Model: Adonis-C1		Date: 21-Apr-00	No.: MA283001
Modified Article: Parts Catalog Correction		Prepared by: S. Tomoe	
From: Technical Services Dept., GTS Division			
Reason for Modification:	<input checked="" type="checkbox"/> Parts catalog correction	<input type="checkbox"/> Vendor change	<input type="checkbox"/> To meet standards ()
	<input type="checkbox"/> To facilitate assembly	<input type="checkbox"/> To improve reliability	
	<input type="checkbox"/> Part standardization	<input type="checkbox"/> Other

To standardize the part with the GSA model, the Right Inner Cover has been changed as follows.

Fig.1

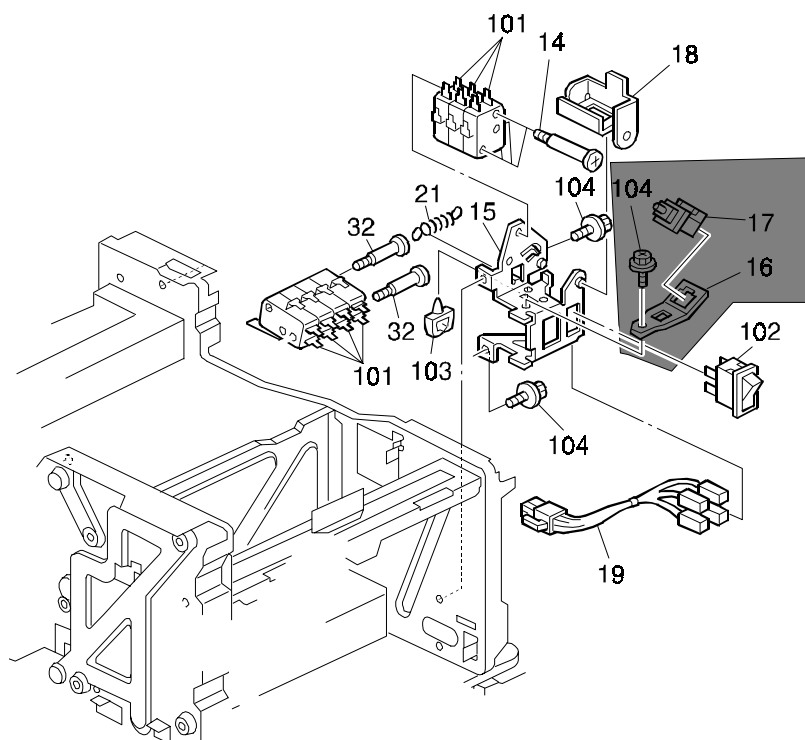
The following should be corrected. Please correct your parts catalog.

Old part number	New part number	Description	Q'ty	Int	Page	Index	Note
A2325867		Angle Bracket – Push Switch	1-0		63	16	Fig.1
AW500022		Push Switch	1-0		63	17	Fig.1
A2323552	A2323561	Ball Bearing – 8x22x7			57	24

No.: MA283005

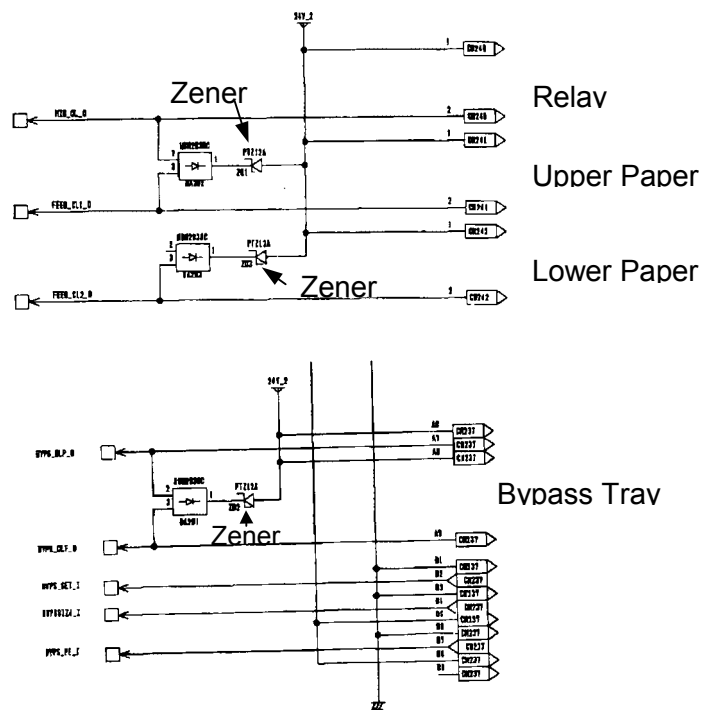
A counter electromotive force flows through the clutch drive circuits and causes the off-timing of the clutch to be delayed. This can result in a paper jam.

A zener diode has been added to the drive circuits of the PFB board for the following clutches, preventing any counter electromotive force from flowing through the circuits:

1. Relay Clutch
2. Upper Paper Feed Clutch
3. Lower Paper Feed Clutch
4. By-pass Tray Feed Clutch

The new part number for the PFB board is as follows:

Old part number	New part number	Description	Q'ty	Int	Page	Index
A2325130	A2325135	PFB Board	1-1	X/O	59	20

No.: MA283007

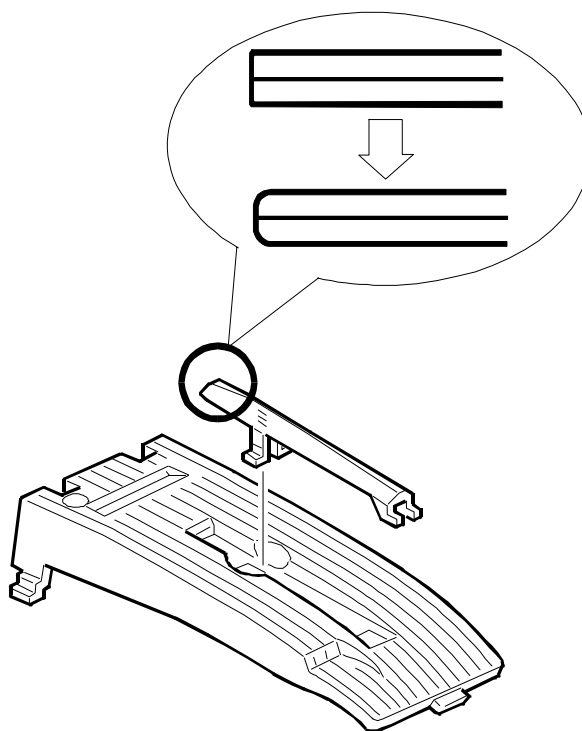
The edge of the Copy Tray Guide has been rounded to ensure that scratches or other minor injuries do not occur.

Old part number	New part number	Description	Q'ty	Int	Page	Index	Note
A2324498	A2844498	Copy Tray Guide	1	X/O	13	2

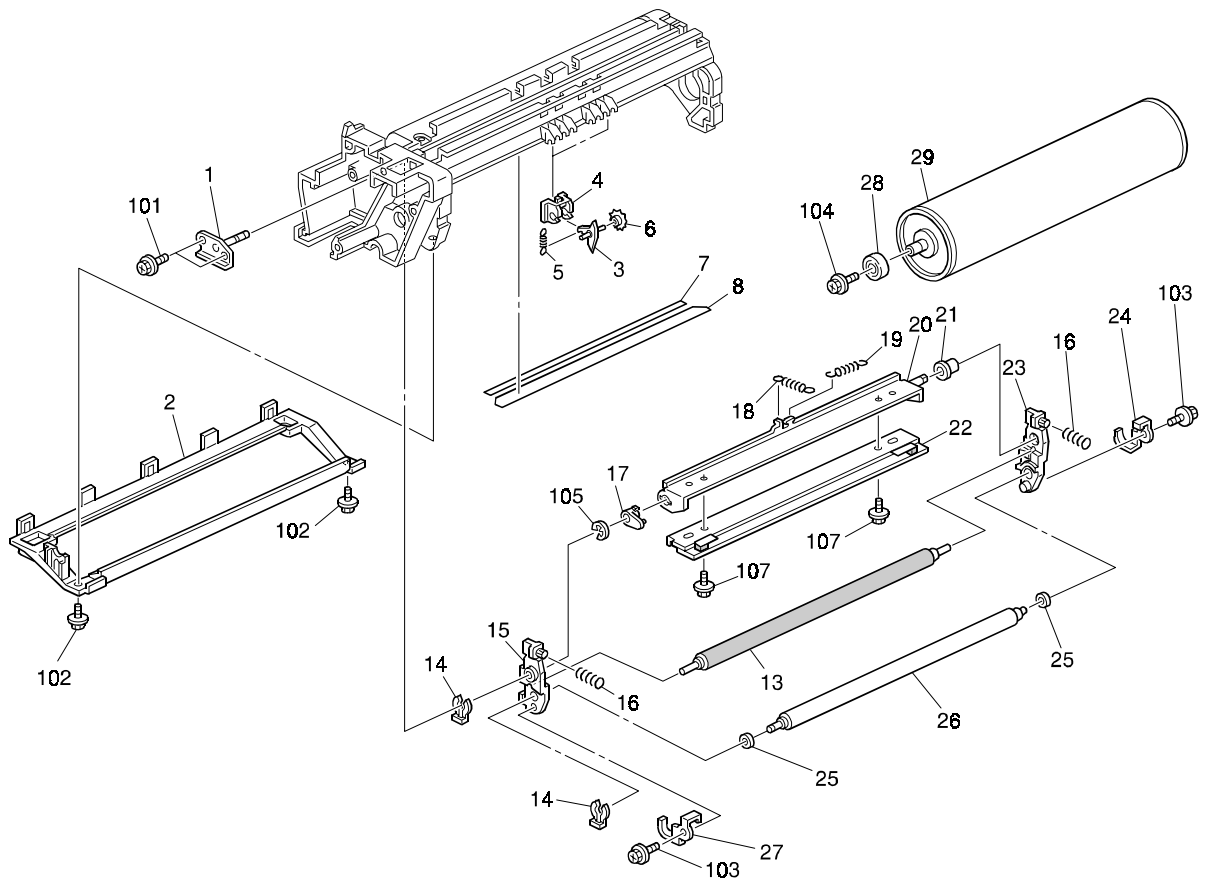
MB003009 announced the change of the Adonis-C2 Cleaning Pad to a Brush Roller, in order to increase Charge Roller cleaning efficiency. The Adonis-C1 has also adopted this new Brush Roller, along with the other related modified parts listed below.

1. For the Adonis-C1, this change affects service parts only, as it has already been discontinued from production.
2. The PCU assembly can be used in machines from before and after this modification (O/O). However, the Cleaning Pad and new Brush Roller are not interchangeable (X/X).

Old part number	New part number	Description	Q'ty	Int	Page	Index	Note
A2327361	A2327361	PCU	1-1	O/O	36 & 38	---	
A2322356	-	Stepped Screw – M6	1-0	-	39	9	
A2322298	-	Bracket – Charge Cleaning	1-0	-	39	10	
AA062301	-	Tension Spring	1-0	-	39	11	
A2322300	-	Roller - Cleaning	1-0	-	39	12	
A2322430	G0652330	Cleaning Pad Brush Roller – Cleaning	1-1	X/X-	39	13	
A2322303	G0652321	Front Arm – Charge Unit	1-1	X/O	39	15	
A2322305	G0652326	Rear Arm – Charge Unit	1-1	X/O	39	23	
AA063561	AA063648	Pressure Spring	2-2	X/O	39	16	
A2322403	G0652270	Receptacle – Charge Roller	1-1	X/X	37	17

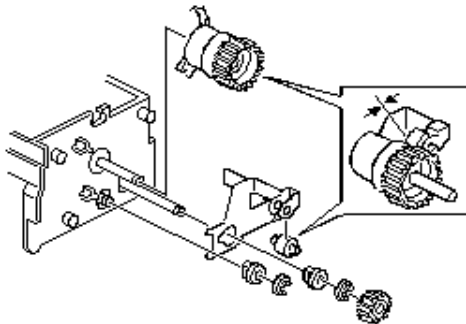
Remove the Tightener Bracket, Retaining Ring, Bushing and Electrical Clutch as shown below.

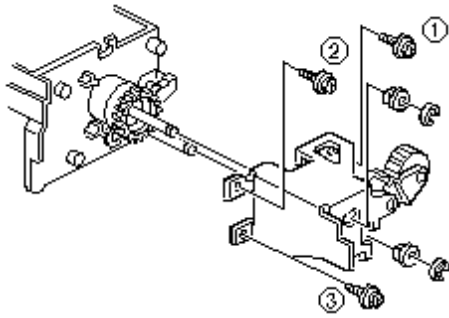
1. Replace the Feed Shaft with AA140753.

2. Attach the Driven Roller [A] to the Pressure Plate [B], then peel off the outer layers of the double-sided tape (2 places) on the Pressure Plate.
3. Set the Bushing [C] in the hole in the Pressure Plate, then mount the two together onto the Feed Shaft.
Note: Be careful not to let the exposed double-sided tape contact the Side Plate.
4. Set Bushing [D] in the cutout on the side of the Pressure Plate, then push in the Pressure Plate along with the two bushings. After it is set in position, attach e-rings [E] and [F].
5. Press the Pressure Plate firmly against the Side Plate so that the double-sided tape catches and secures the two together.
6. Attach the Gear [G].
7. Attach the Electrical Clutch [H].

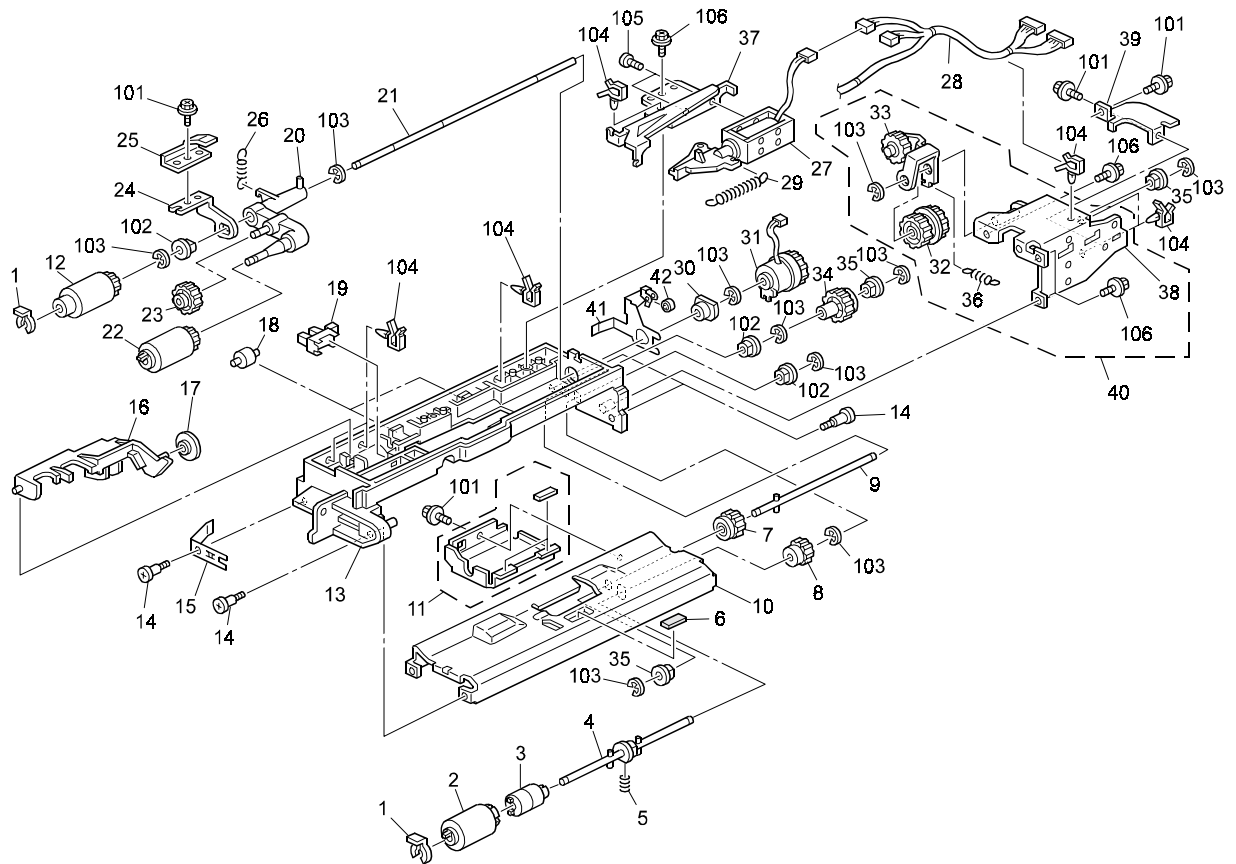
8. Remove the Arm Tightener, Gear and Spring attached to the Tightener Bracket removed in the Prep stage above, then attach them to the new Tightener Bracket [I].
9. Attach the Tightener Bracket [I] and Bushings [J] and [K]. Then, the tighten screws in the order shown.
10. Attach e-rings [L] and [M].
